Access Compliance Report

Public Rights-of-Way

(Pedestrian Signals)

Intersection ID: N/A	Main Street:	Cross Street: N/A	Location: N/A
ADA ID: 036A9361AAFE	Signal Type: One Push Button-APS	Overall Compliance: No	Severity Score: BTN 1: N/A BTN 2: N/A No BTN: N/A
Codes/Mitigation Info/Possible Solution		Field Measurements/Component Compliance

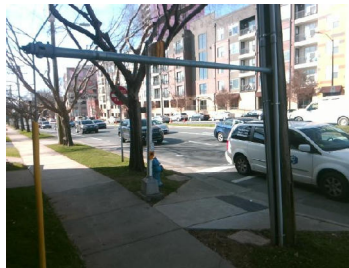
PROW/ADA: TMUTCD 4e.08, R406.2, R209.1, MUTCD 4e.10

Yes B 1 Clear Xing Direction?	ClearlyMarked	N/A B 2 Clear Xing Direction?	N/A
B 1 Crossing Direction	To NW	B 2 Crossing Direction	N/A
Yes B 1 DistanceTo XWalk (in)	0.0	N/A B 2 DistanceTo XWalk (in)	N/A
No B 1 DistanceTo Curb (in)	88.0	N/A B 2 DistanceTo Curb (in)	N/A
Yes B 1 Diameter (in)	2.0	N/A B 2 Diameter (in)	N/A

Possible Solutions: Replace Signal Push Button With APS Button on New Post. Remove & Relocate Sign.
